Mobile Intel[®] Celeron[™] Processor at 466 MHz, 433 MHz, 400 MHz, 366 MHz, 333 MHz, 300 MHz, and 266 MHz Specification Update

Release Date: May 2001

Order Number: 244444-025

Figure 2. Workaround Flowchart: SMBALERT#-Driven System

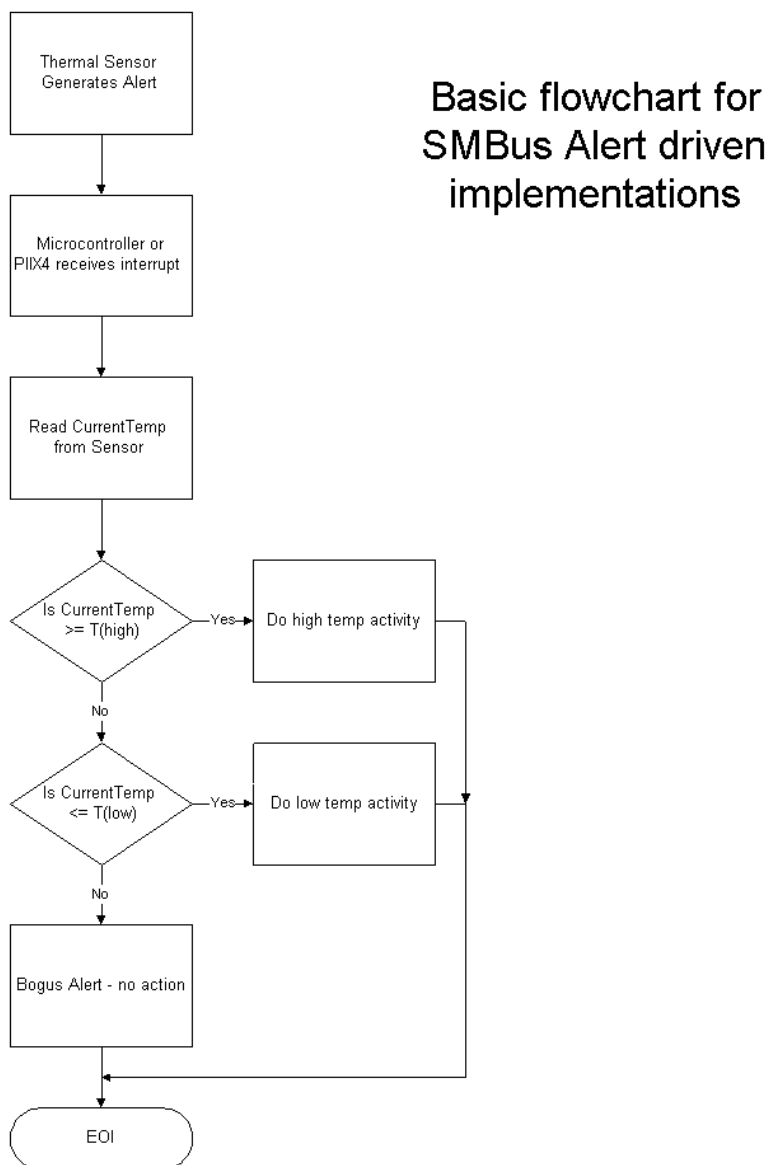
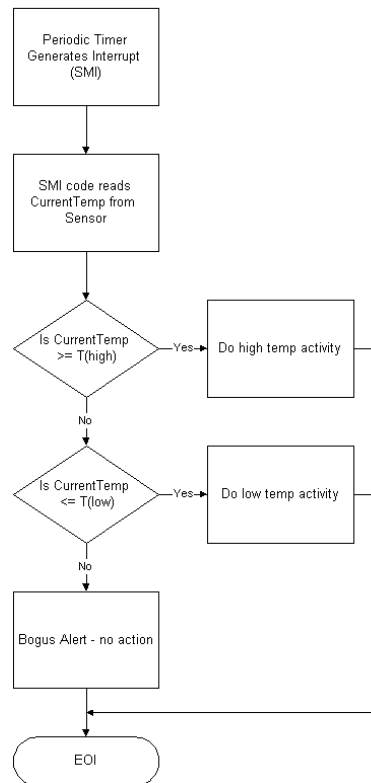
H29. Thermal Sensor May Assert SMBALERT# Incorrectly

Problem: The Intel Celeron Processor Mobile Module has a thermal sensor that monitors the processor core's temperature. Please note that desktop systems could have a similar thermal device. The thermal sensor asserts SMBALERT# if the processor temperature exceeds the temperature limits set in the Alarm Threshold Registers (T_{HIGH} , T_{LOW}). It also sets the corresponding Status Register bits to identify the cause of the interrupt. Figure 1 gives one example of the how the SMBALERT# signal could be used in a system.

Workaround: Three different (mutually exclusive) workarounds are possible:

1. Before servicing an interrupt from the thermal sensor, read and compare the processor thermal reading with the threshold limits (T_{HIGH} or T_{LOW}). Figures 2 and 3 provide basic flowcharts for the implementation of this workaround in an interrupt driven system.
2. If the firmware implemented polls the Status Register only, then before taking any action, re-read the temperature register and do a comparison with the alarm threshold limits (T_{HIGH} or T_{LOW}) to determine if the value is actually still within the temperature window.
3. Use a temperature polling scheme to monitor the processor temperature.

Figure 5.3. Surface-Mount BGA1 Package—Top and Side View

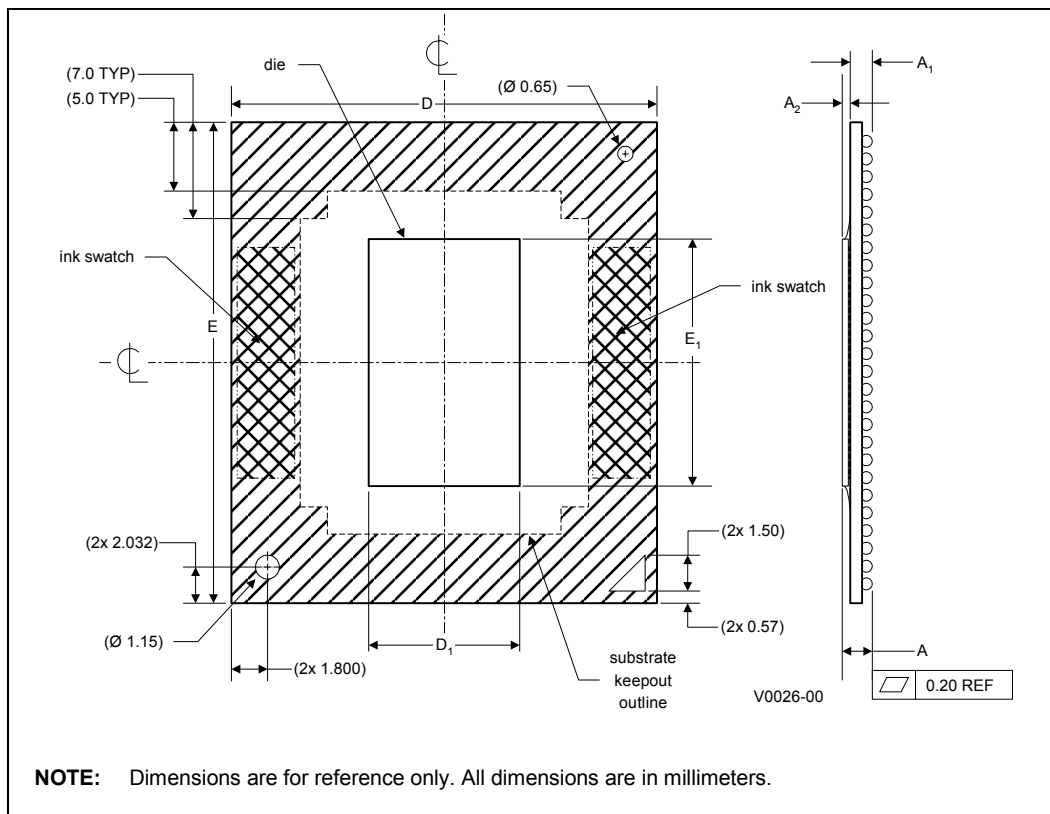
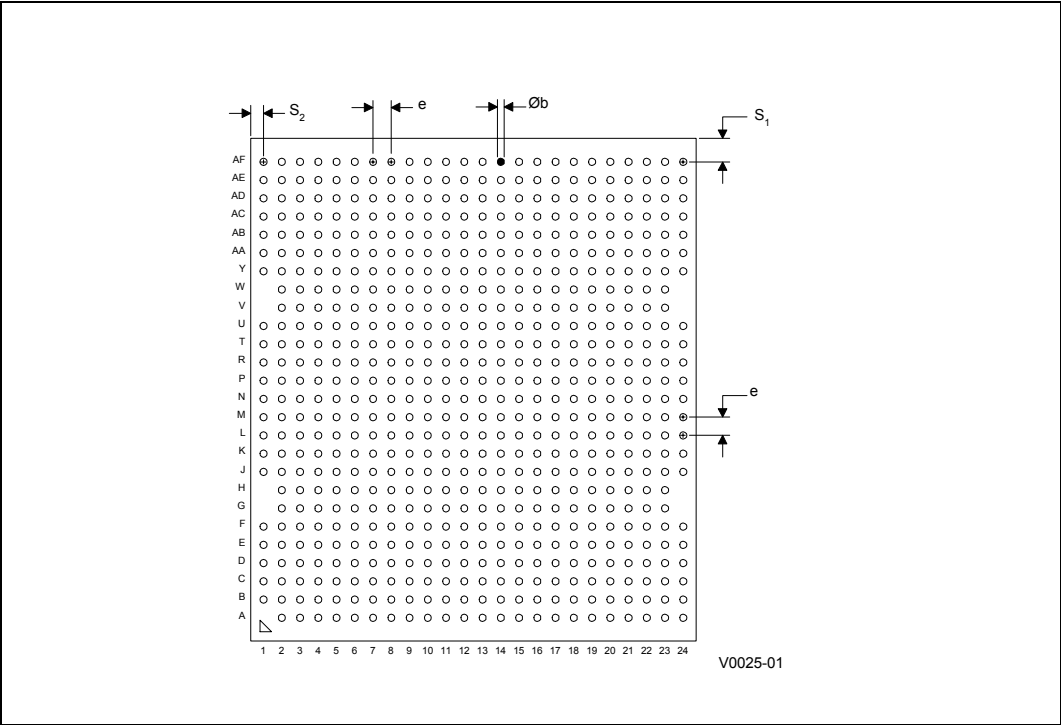
The following table and figures show the updated mechanical specifications for the BGA1 package, listed as Table 5.2, Figure 5.3 and 5.4, respectively, in the *Intel® Mobile Celeron™ Processor in BGA Package at 333 MHz, 300 MHz and 266 MHz* datasheet.

1. The number shown here is different from that in the 244444-004 version of this specification update. The maximum reference number is used.

Figure 3.3 Generic Clock Waveform

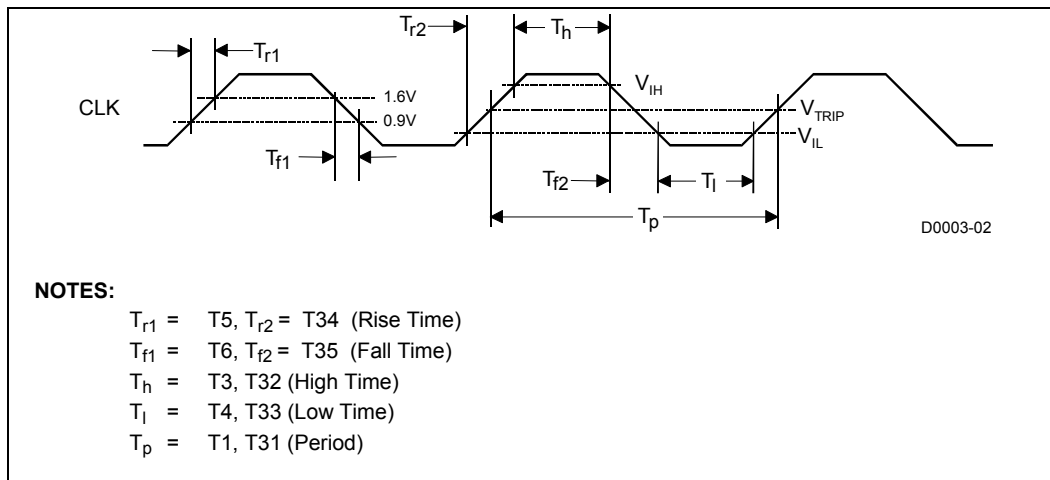
H11. Generic Clock Waveform Figure

Figure 3.3 in the Intel® Mobile Celeron™ Processor in μ PGA1 and BGA1 Packages at 366 MHz, 333 MHz, 300 MHz, and 266 MHz datasheet (Order Number 245112-003) has been updated. The following figure is to replace the one in the above document.
